Paycor Stadium Southeast & Southwest VT Escalator Towers
Bid Package 3: Architectural & MEP
ITB#037-26
Addendum 2

May 12, 2026

DRAWING NUMBER ISSUE
A-213.4 3.2

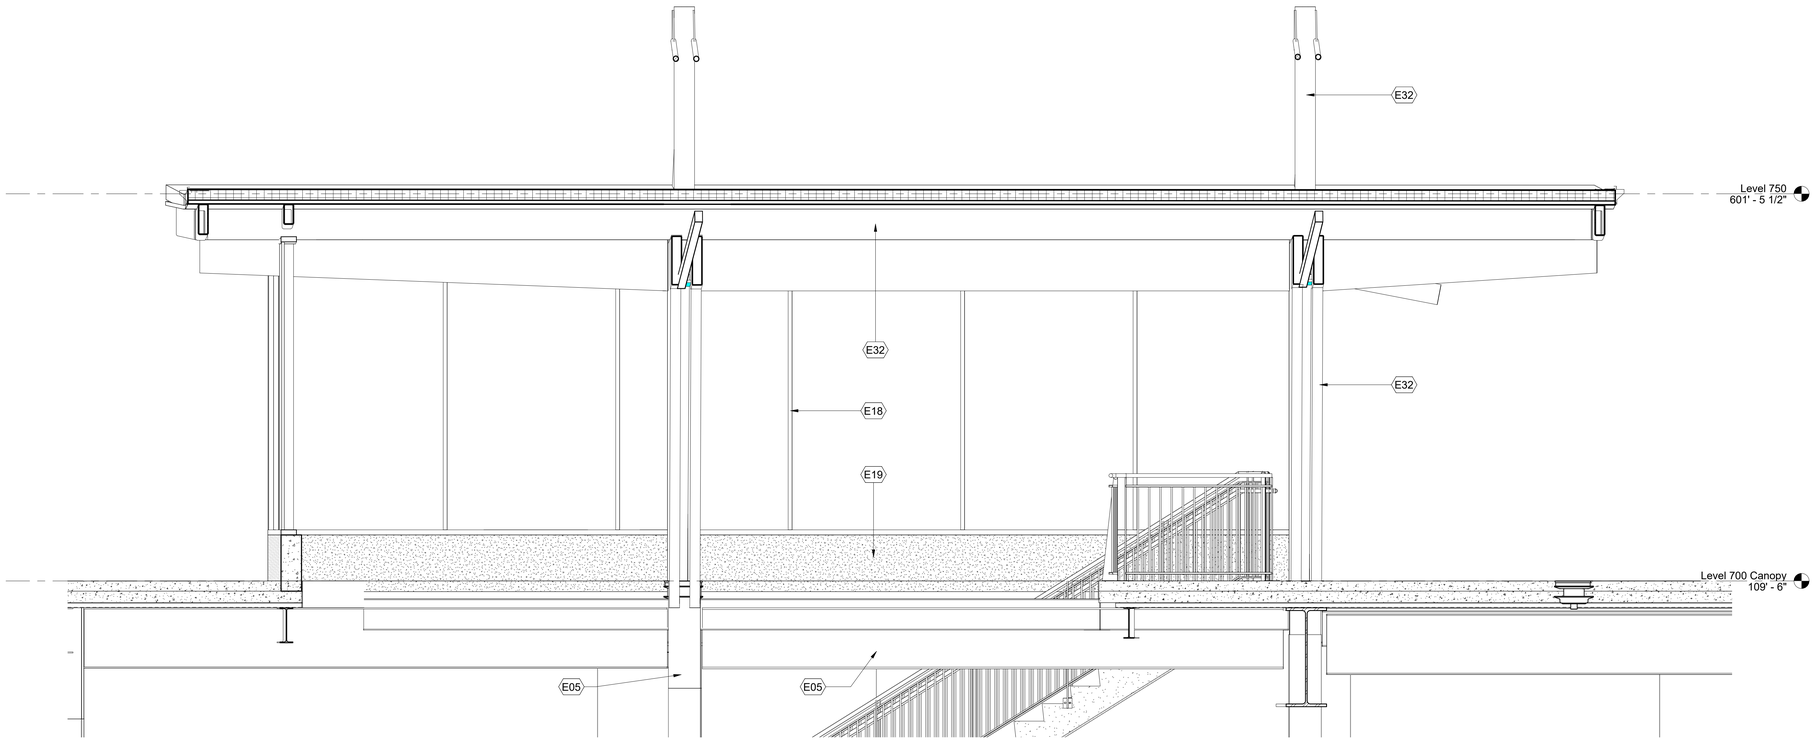
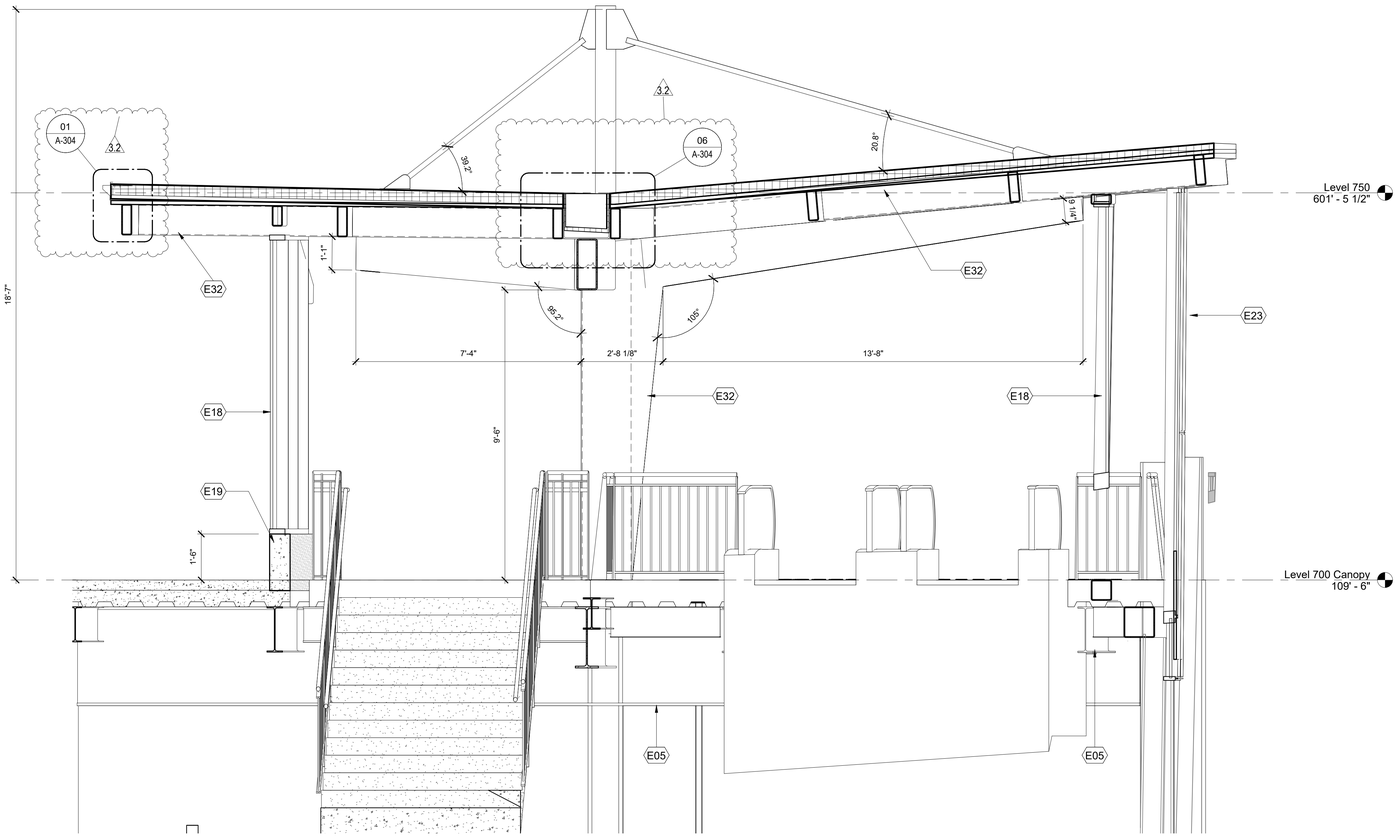
2.6 A-213.4, A- 213.9
- 2.6.1 Revision to center gutter.
- 2.6.2 Detail Markers added.

SECTOR 9 - HEAD HOUSE ELEVATIONS

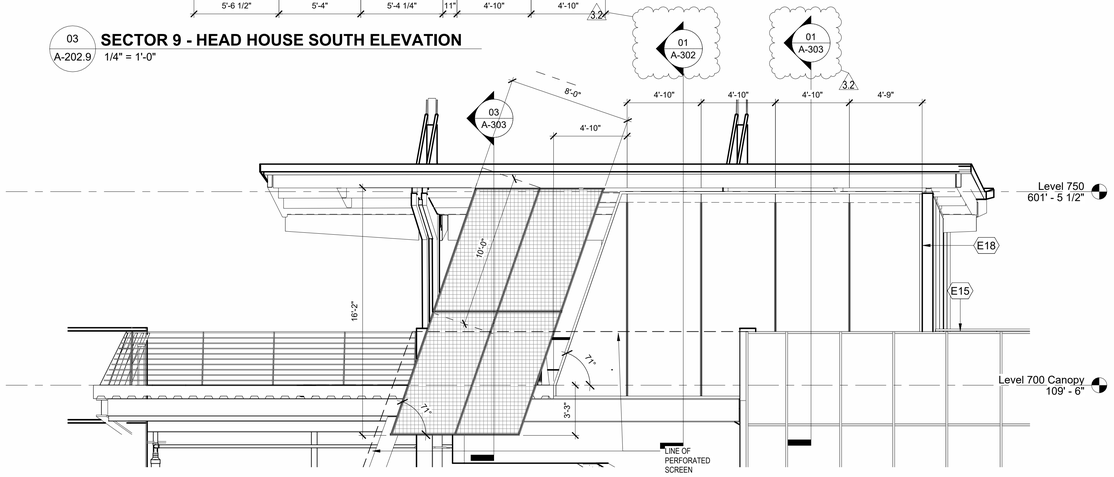
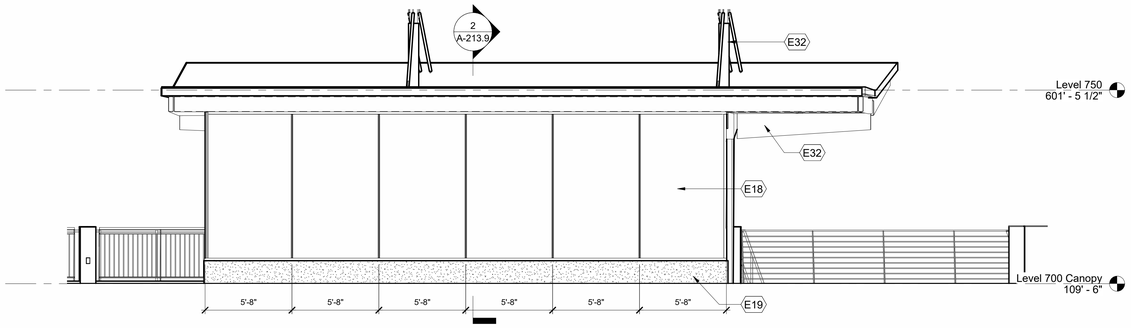
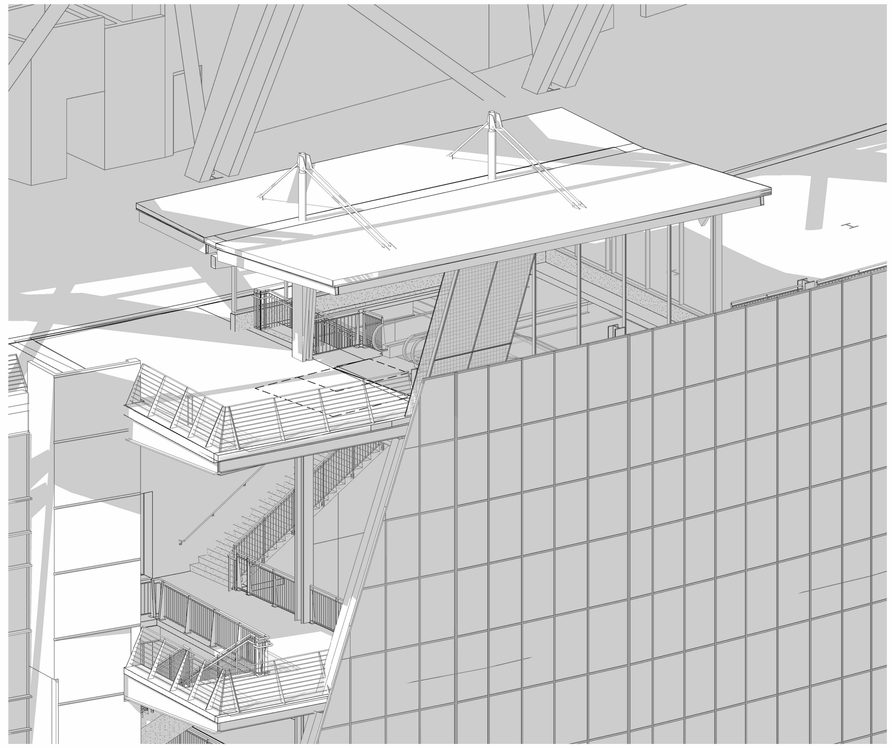
2.5 A-202.4, A-202.9
- 2.5.1 Revision of perforated metal screen
- 2.5.2 Section/Detail markers added to Headhouse Elevations.

09 A-503 **LEVEL 700 EDGE DETAIL W/RAILING**
1 1/2" = 1'-0"

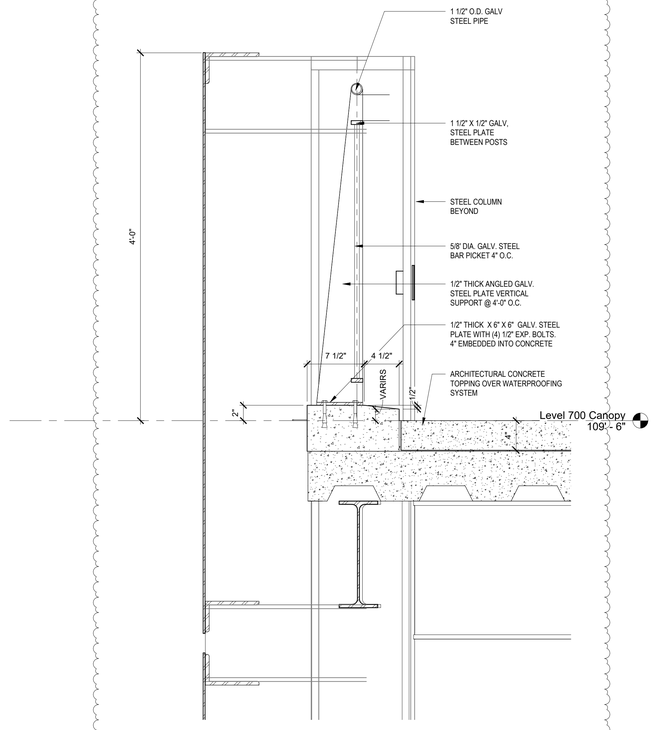
2.10.1 Detail 09/A503 Revised.

ELECTRICAL PARTIAL PLANS LEVEL 200 NEW WORK POWER

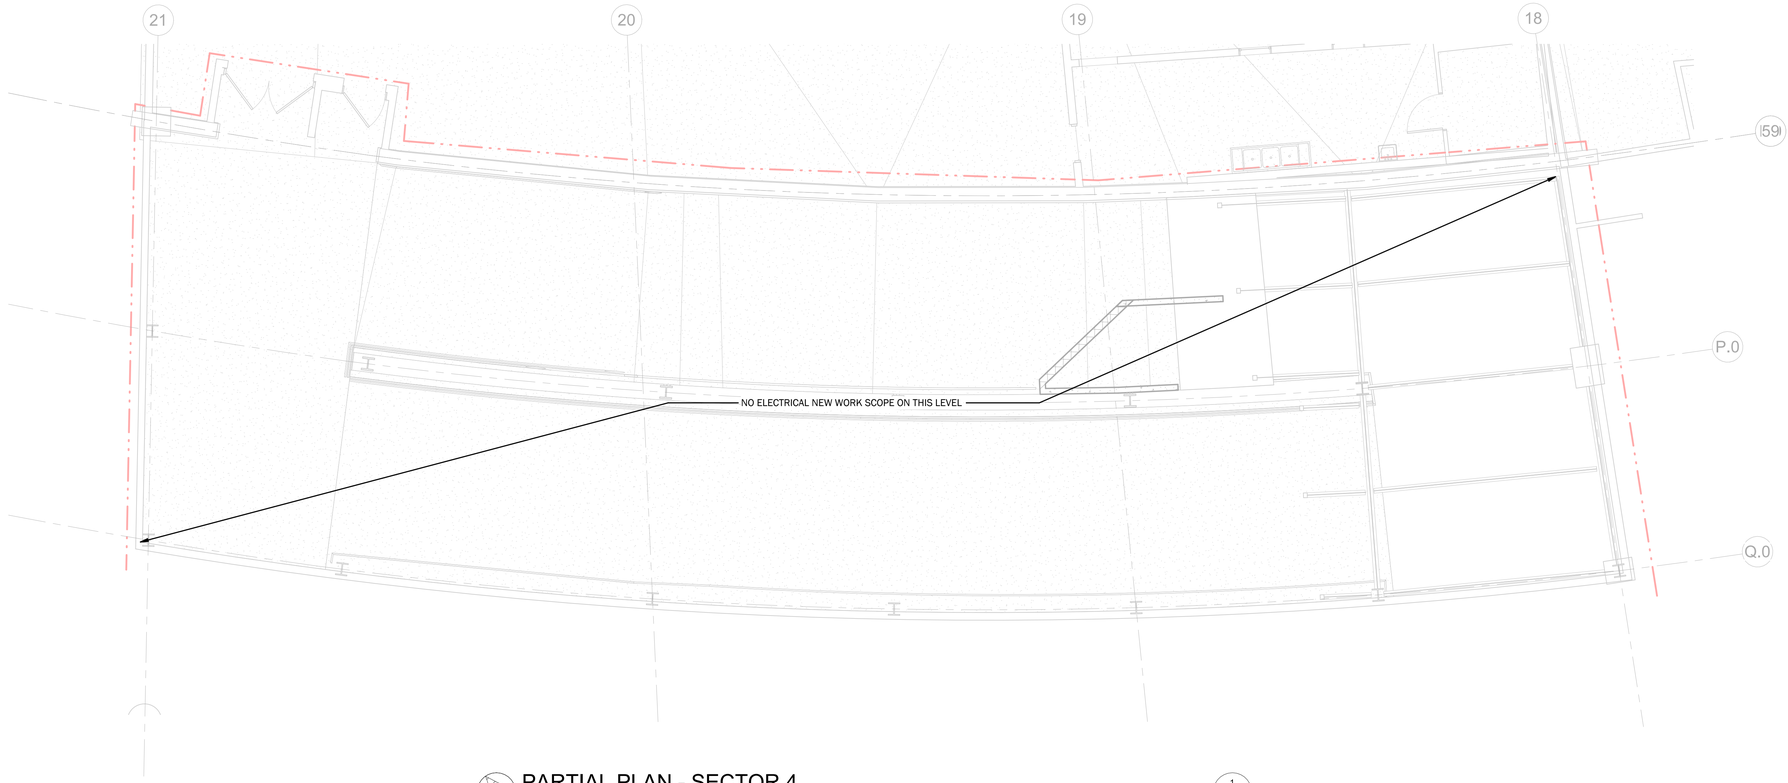
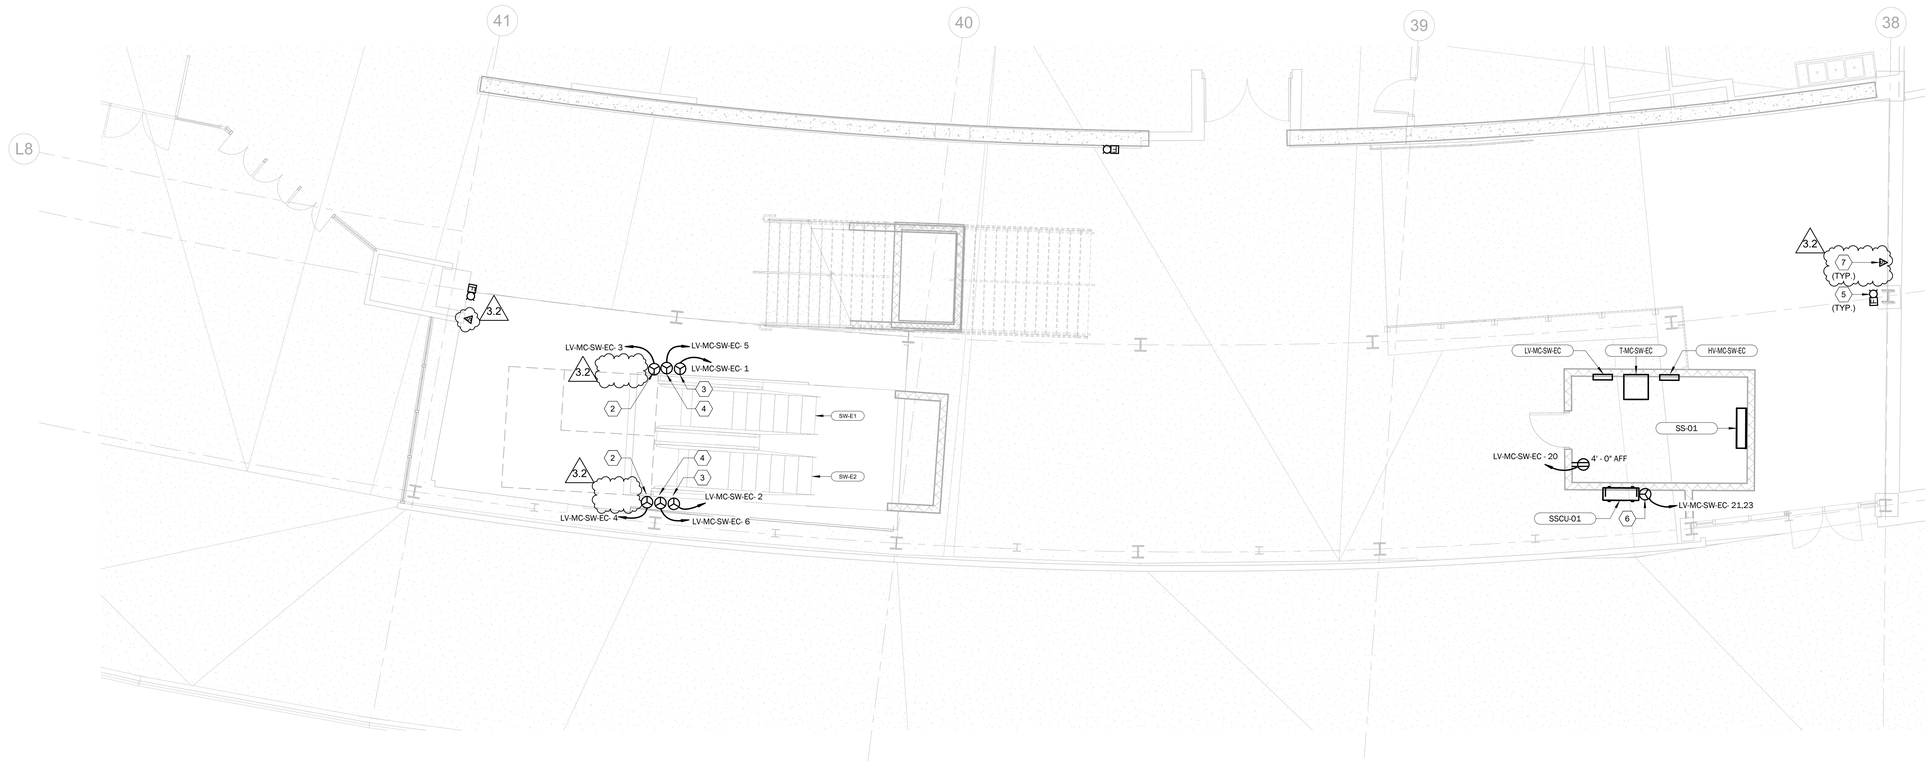
2.20 E200: ELECTRICAL PARTIAL PLANS LEVEL 200 NEW WORK POWER

2.20.1 Added speakers.

ELECTRICAL PARTIAL PLANS LEVEL 300 NEW WORK POWER

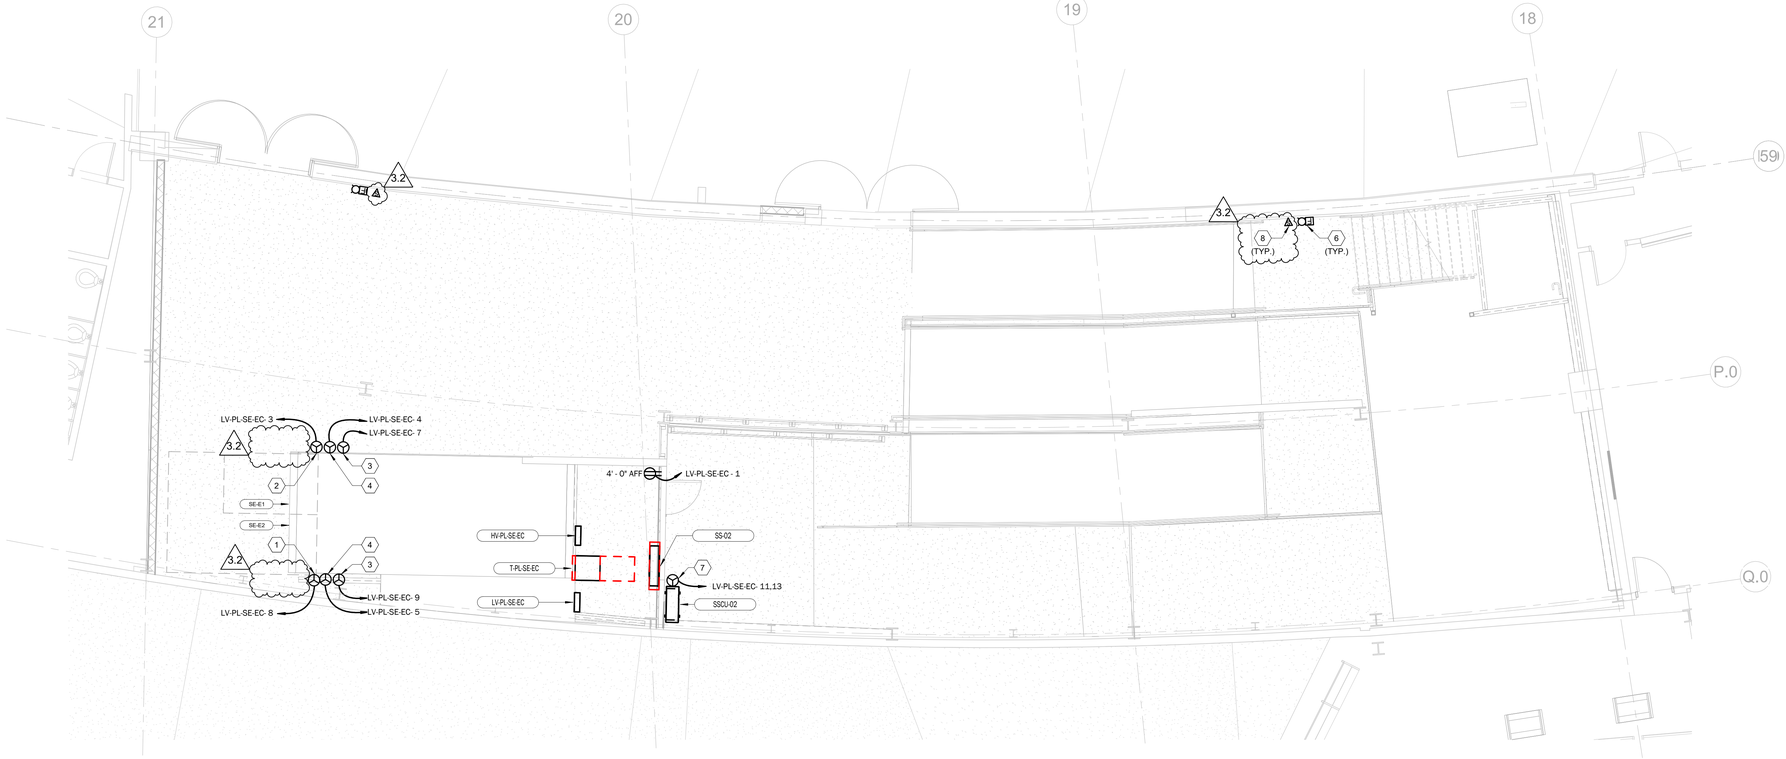
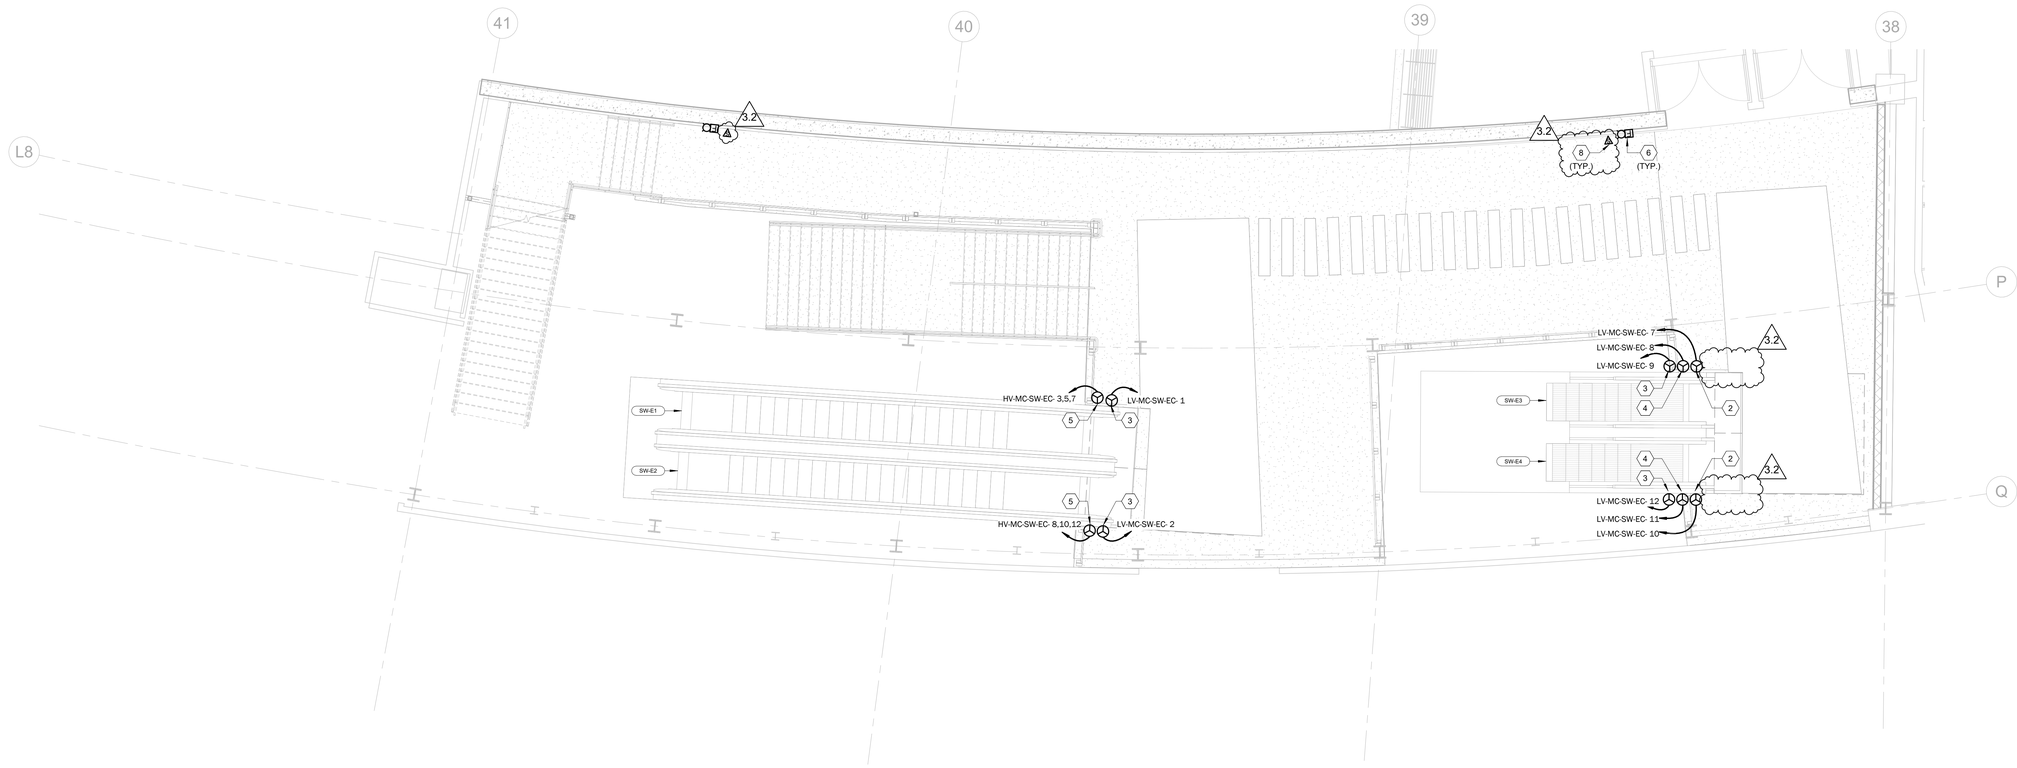
2.21 E201: ELECTRICAL PARTIAL PLANS LEVEL 300 NEW WORK POWER

2.21.1 Added speakers.
